## bushfire protection assessment addendum

Proposed Cemetery – Macarthur Memorial Park  
Lot 1 DP 218016, Lot B DP 370979  
& Lot 22 DP 564065  
166 - 176 St Andrews Road, Varroville

July 2018  
(REF: 18NETT02 / A16228B)

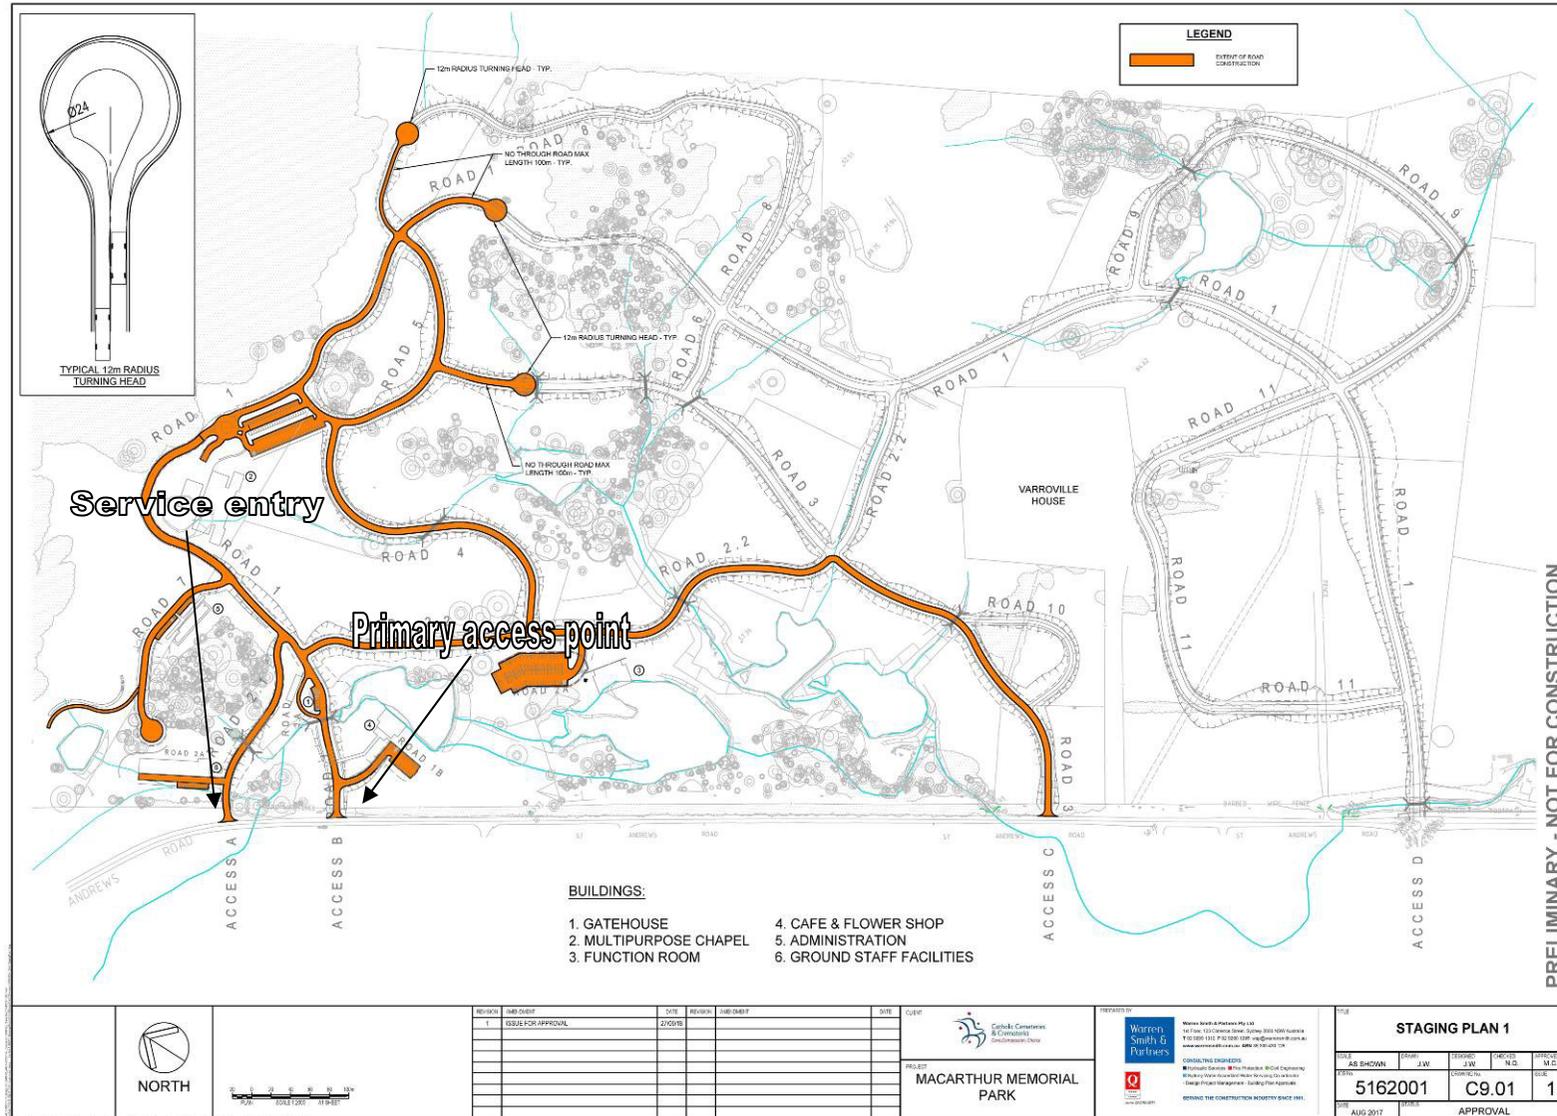
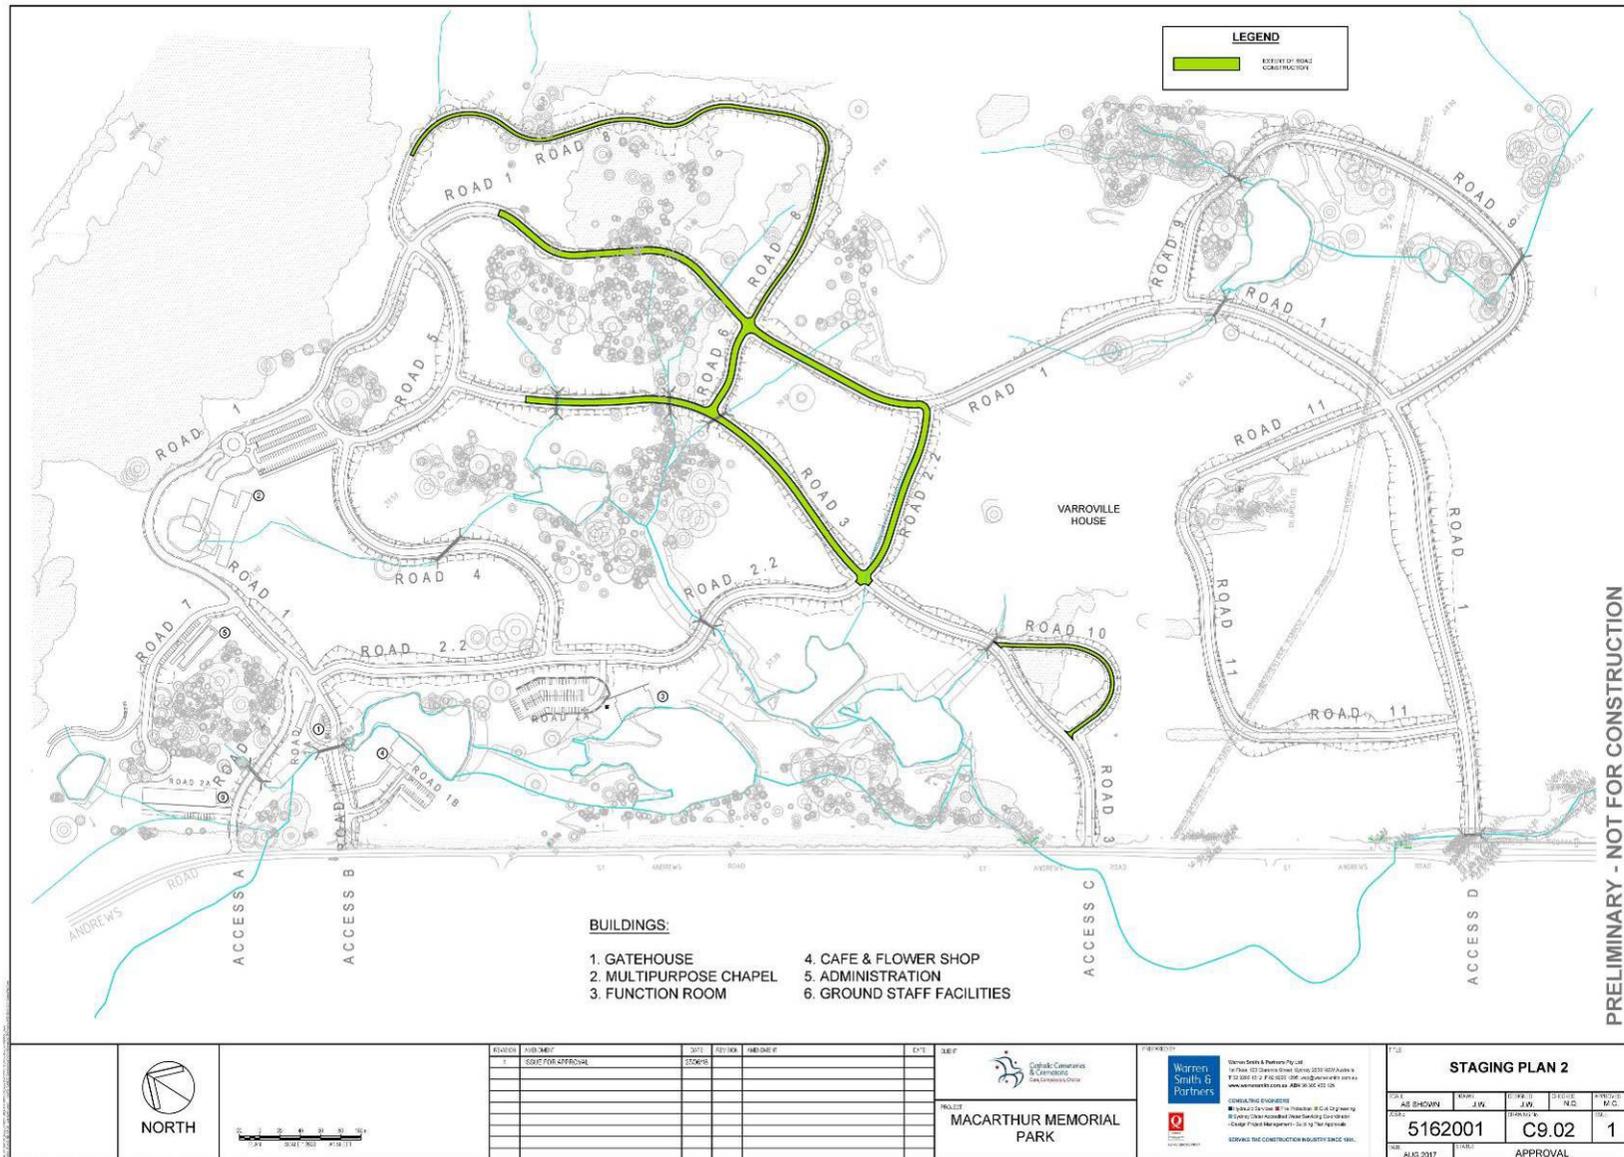
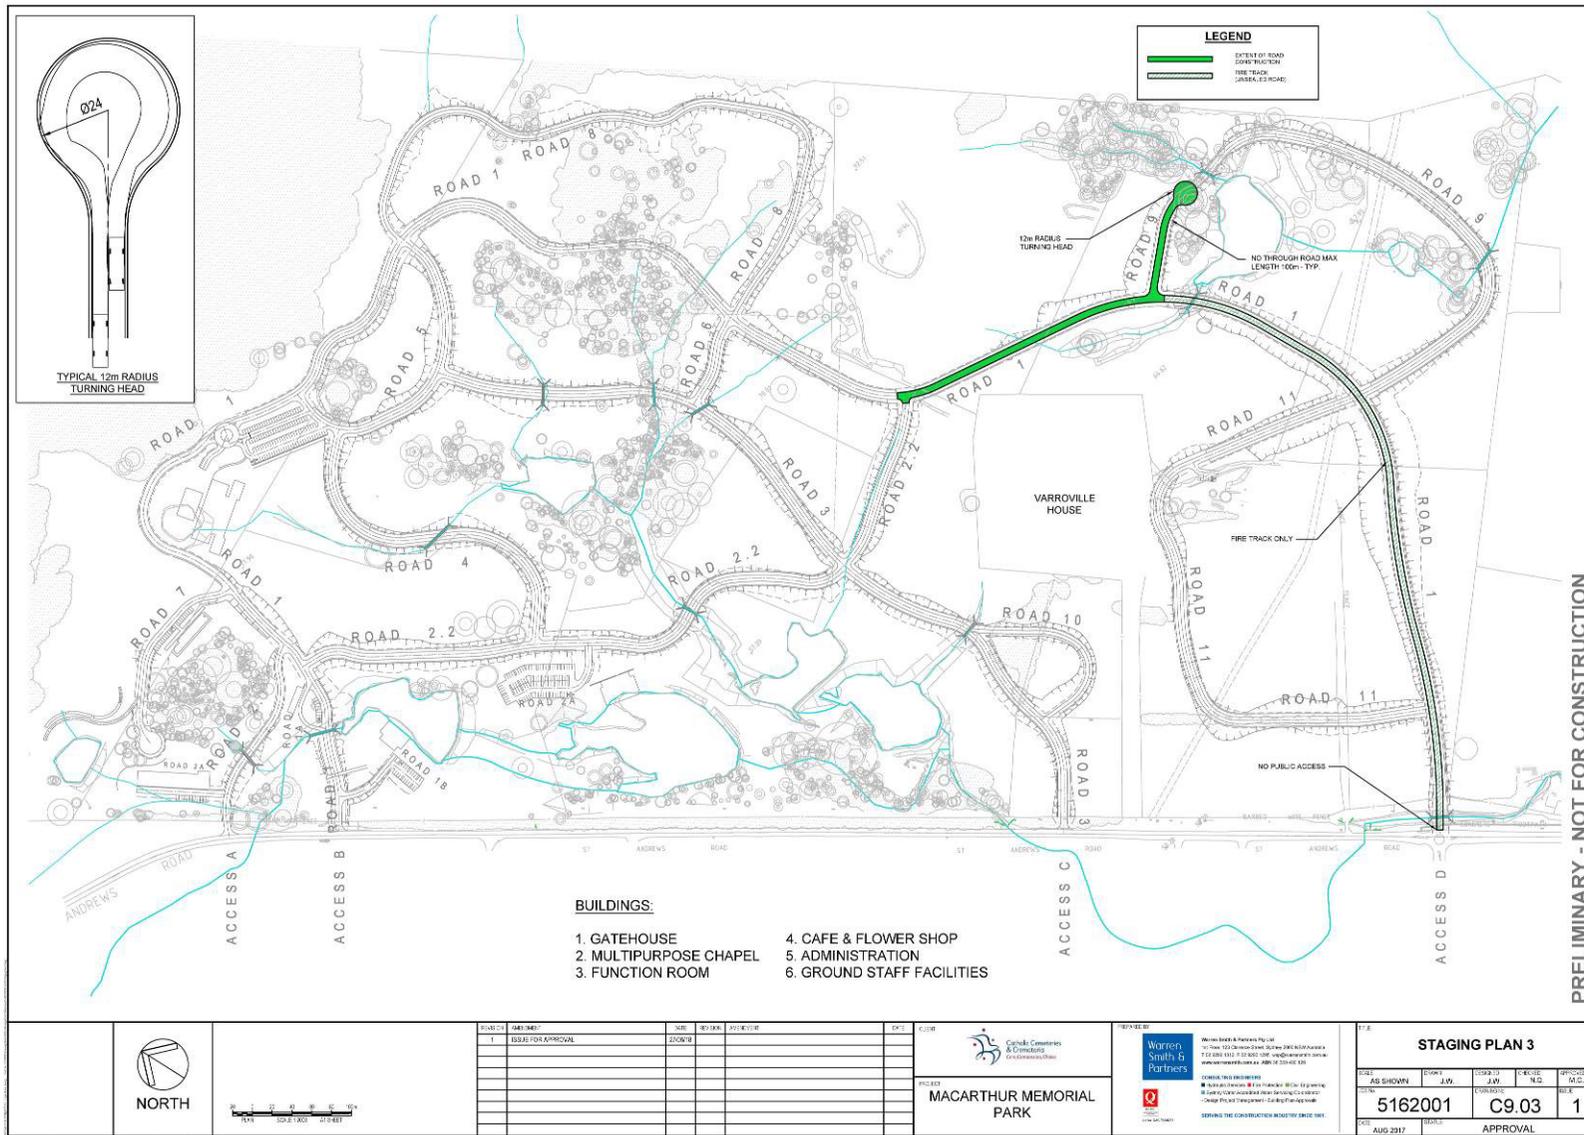
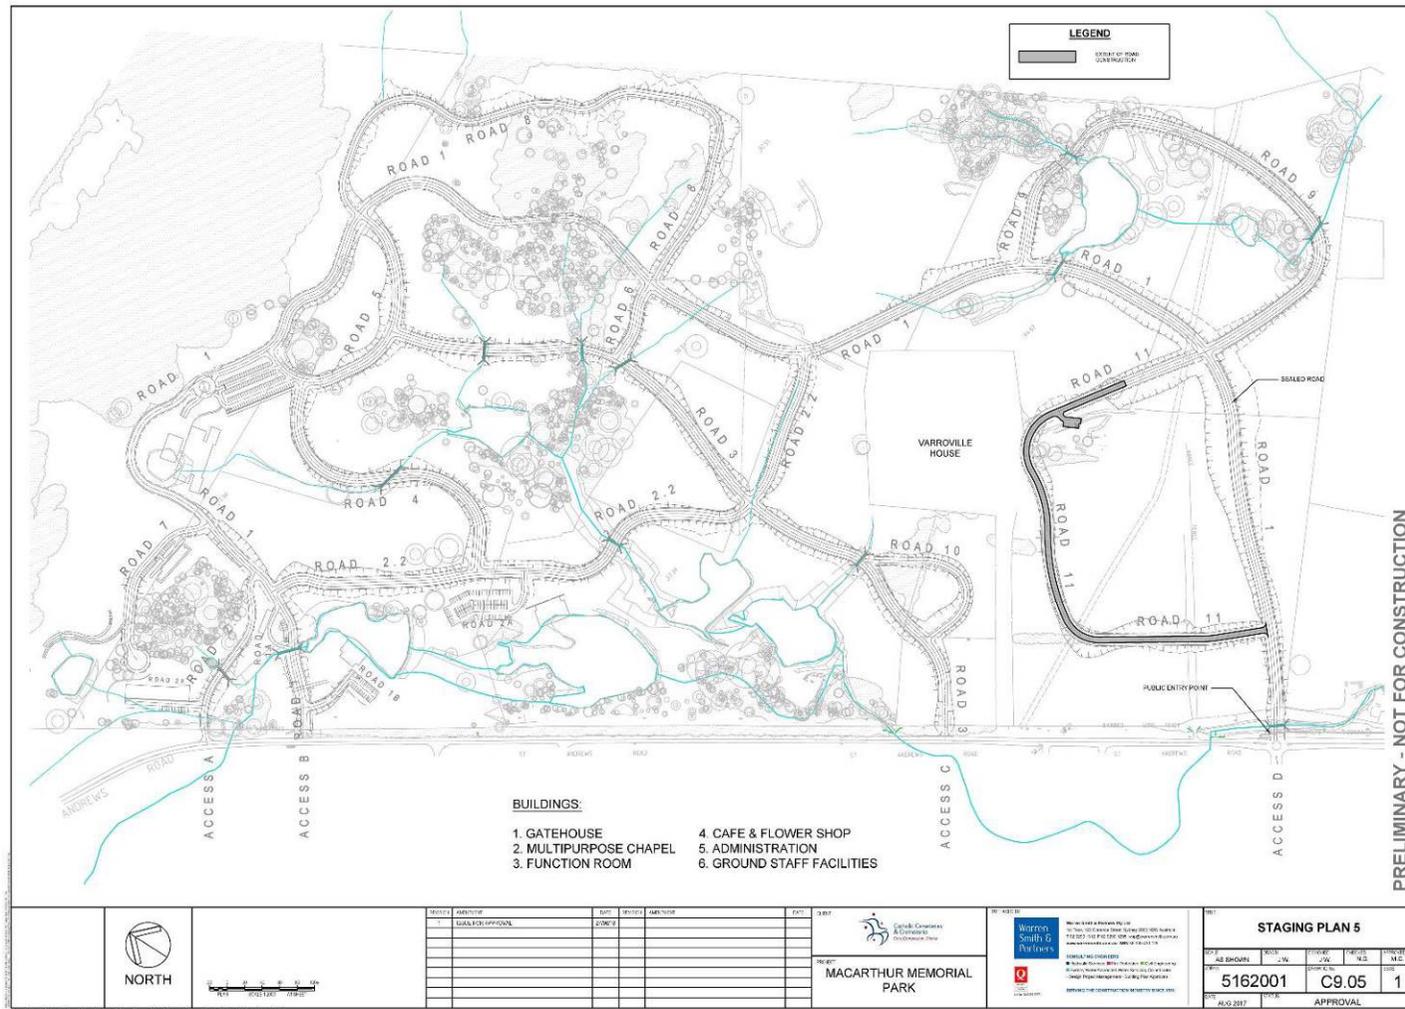
RFI	TBE Comment
<p><b>RFI 1.3</b> – <i>The proposed road width and verges are excessive and intrusive within the wider Varroville landscape.</i></p>	<p>Road design / width has been minimised to the maximum extent allowable under Section 4.2.7 of <i>Planning for Bushfire Protection 2006</i> and the New South Wales Rural Fire Service (RFS) comments which were received for the planning proposal in December 2015 (RFS ref: L13/0010).</p> <p>A performance based / alternative solution approach was undertaken to reduce road widths to 6.5m (two-way) and 3.5m (one-way) for all roads <u>regardless of curve radius</u> as well as the 2.1m wide grassed parking to enable safe access for emergency services and visitors to the site. A pre-DA meeting was held with the NSW RFS (refer Appendix 3) and pre-approval was granted for this approach.</p>
<p><b>RFI 7.1</b> – <i>Additional information is required to demonstrate that all internal roads for each stage will be through roads or dead ends no longer than 100m with a 12m outer radius turning circle, noting that some roads in Stage 1 &amp; 4 will be dead ends until later stages are completed</i></p>	<p>A review of the staging plan has been undertaken and temporary dead end roads will be provided within Stage 1, Stage 3 &amp; Stage 4. These dead end roads will be no longer than 100m and will be provided with a 12m outer radius turning circle.</p> <p>There is a dead end road (accessing the administration building) which has a length of 200m and dead end road accessing the maintenance building which does not have a turning head. As detailed within Section 3.4 these roads comply with the performance criteria based on the low bushfire risk, surrounding maintained land, proposed use and environmental constraints.</p>

The proposed road network has been designed to allow access to each of the built facilities and various burial and memorial sites throughout the development. All two-way roads are proposed to have parallel parking on both sides and one-way roads to have parallel parking on one side. The primary access point to the development will be provided at the western boundary to provide direct access to the café and gatehouse (refer Figure 3.1).

<b>PROJECT &amp; MXD REFERENCE</b> St Andrews Road, Varroville 18NETT02_FMP002	<b>DATE &amp; ISSUE</b> 11/07/2018 Issue 1	<b>SCALE &amp; COORDINATE SYSTEM</b> 1:1,000 @ A4 GDA 1994 MGA Zone 56	
	<b>TITLE</b> <b>Figure A2 - Fuel Management Plan (Administration)</b>

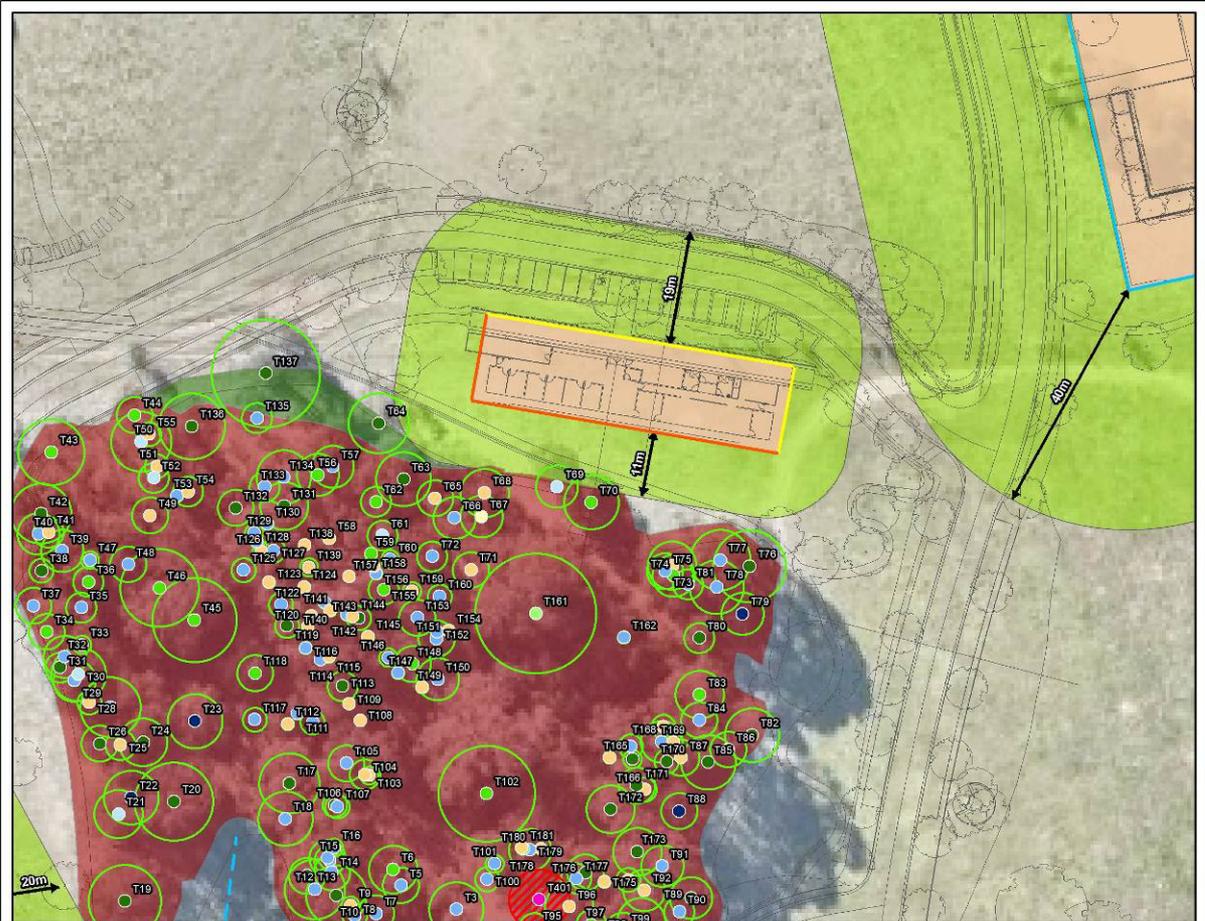
RFI	TBE Comment
<p><b>RFI 7.2</b> – <i>The bushfire report must be amended to detail how the proposed APZs around buildings will be achieved given the requirement to maximise the conservation of trees - e.g. will this be through weed removal, modification of understory, trimming of canopy. A detailed plan of proposed APZ works is required and this must be consistent with the FFAR and the VMP</i></p>	<p>Further detail has been provided within Section 3.3 and Appendix 1 to provide further detail on APZ management requirements.</p> <p>The Vegetation Management Plan (VMP) has been updated to detail the APZ management requirements. The APZ impacts have been included within the Flora &amp; Fauna Report and are consistent with the APZs determined within this report.</p>

A summary of the guidelines for managing APZs along with supporting *Figures A1 – A4 - Fuel Management Plan* is attached within Appendix 1 of this report.
